**STATEMENT TO PLANNING PANELS
VICTORIA BY JASON LEE WALSH, TRAFFIC
ENGINEER**

AMENDMENT C259 TO THE GREATER GEELONG PLANNING SCHEME

HORSESHOE BEND PRECINCT

Evidence Statement

Plan 10A: Interim Road Hierarchy

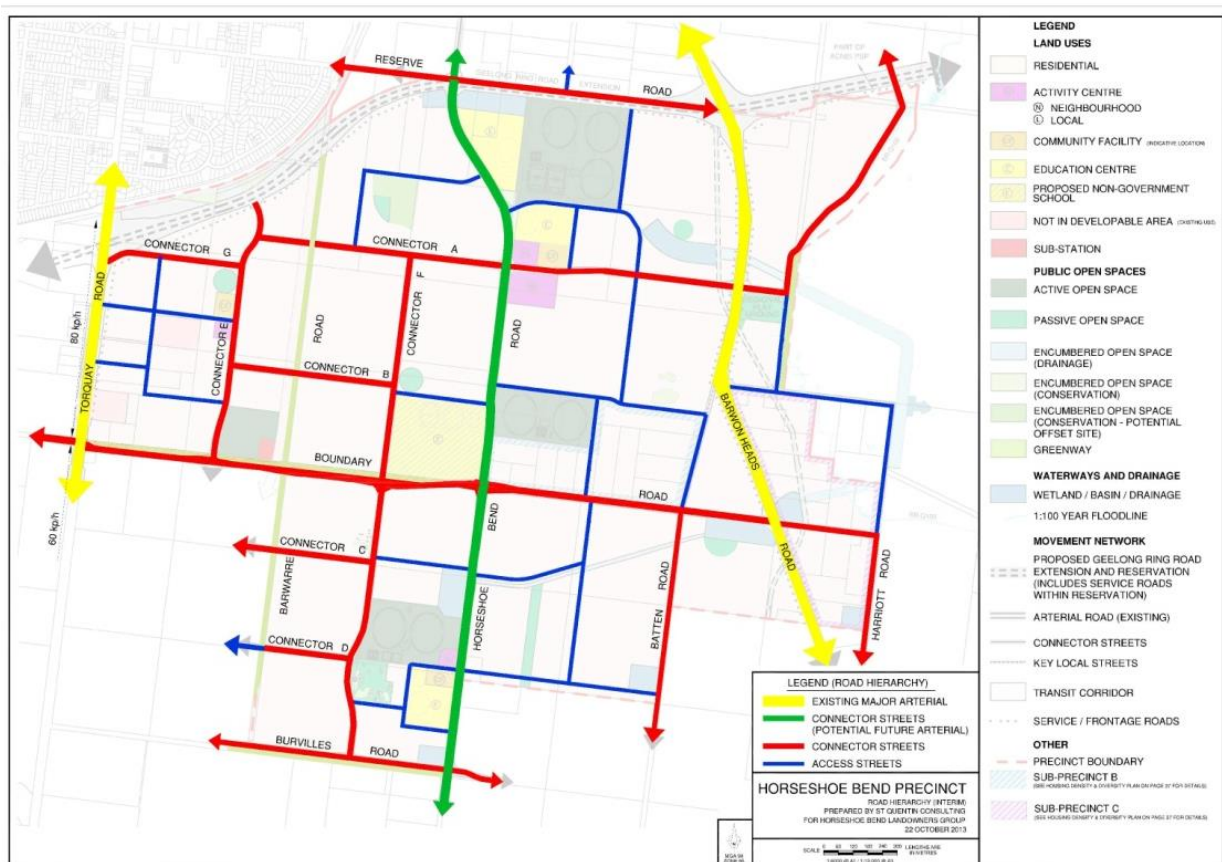
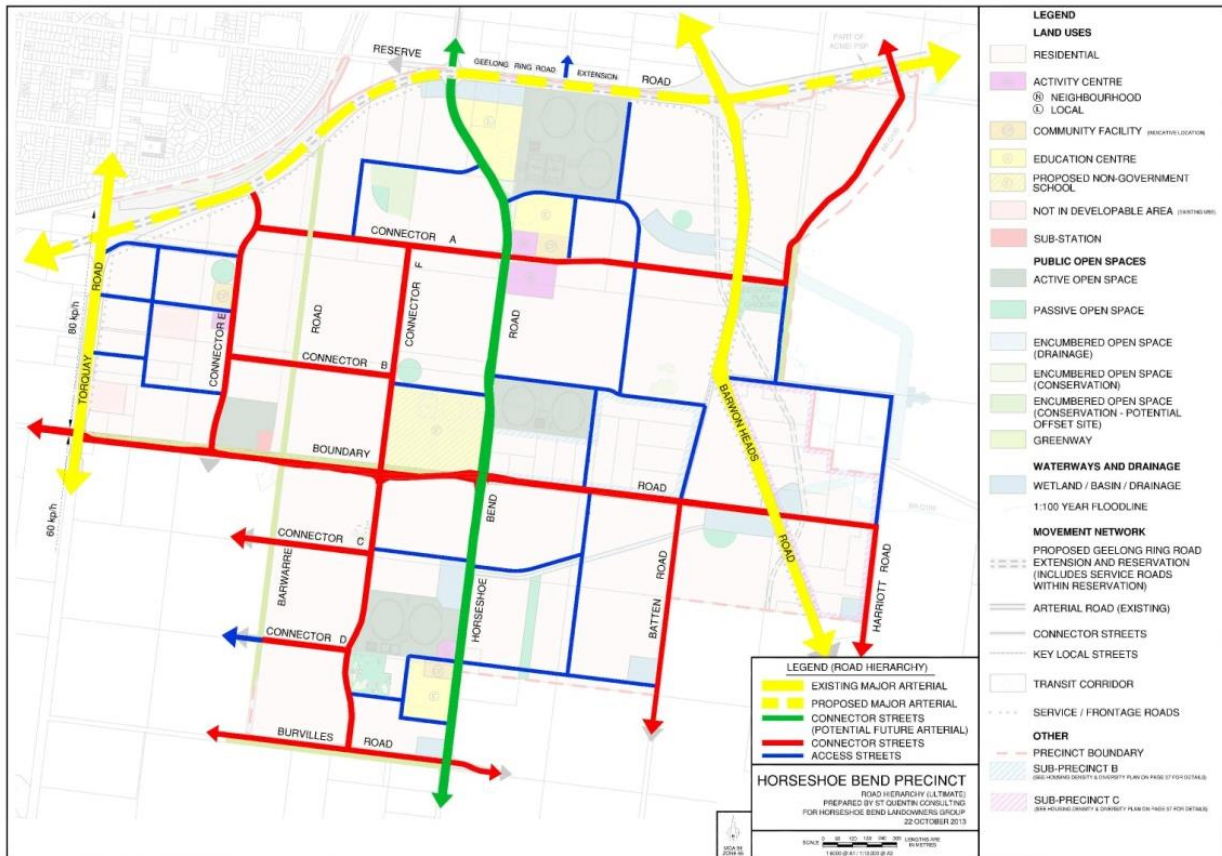
In my review, I have identified that there is a discrepancy between the Road Hierarchy plans presented in the PSP, being Plan 10A 'Road Hierarchy (Interim)' and Plan 10B 'Road Hierarchy (Ultimate)', and Cardno Figure 5-2 'Horseshoe Bend PSP Road Network'. The Cardno hierarchy plan follows.

Specifically, the proposed road network in the north-west corner of the precinct, in the area fronting Torquay Road differs between the Cardno recommendations and the PSP (see the circled area). The PSP plans show a connection to Torquay Road with Connector G, as well as two (2) other local access streets, whereas the Cardno plan illustrates the Connector G connection to be removed in the 'ultimate' scenario, and only a single other local road connection.

<p>PSP #7. Page 60, Plan 10B Connector G is shown as an access street on Plan 10B, but is still shown as intersecting with Torquay Road. It is understood that this intersection will be removed in the ultimate (i.e. when ACEWLR is built). Plan 10B should be altered to show this.</p>	<p>Agree – The Hierarchy Plan should be clearer in establishing that Connector G will not ultimately connect to the Surfcoast Highway.</p>
	<p>PSP #8. Page 60, Plan 10B The Connector E intersection with ACEWLR may be too close to the ultimate Torquay Road ramps. This will require further investigation.</p>	<p>Noted.</p>
	<p>PSP #9. Page 59/60, Plan 10A/B The access street intersection with Barwon Heads Road (between Connector A and Boundary Road) should be left turn in/left turn out only. The plan should be annotated to indicate this.</p>	<p>Subject to the other roads being available for access, this item is agreed.</p>

In relation to this discrepancy, I am instructed the hierarchy and road network layout proposed by the Cardno plan is to be adopted. This will include a single local access street connection to Torquay Road (in a left-in/left-out arrangement) and the Connector G link to Torquay Road to be truncated in the future and converted to an internal connection to a frontage road or similar.
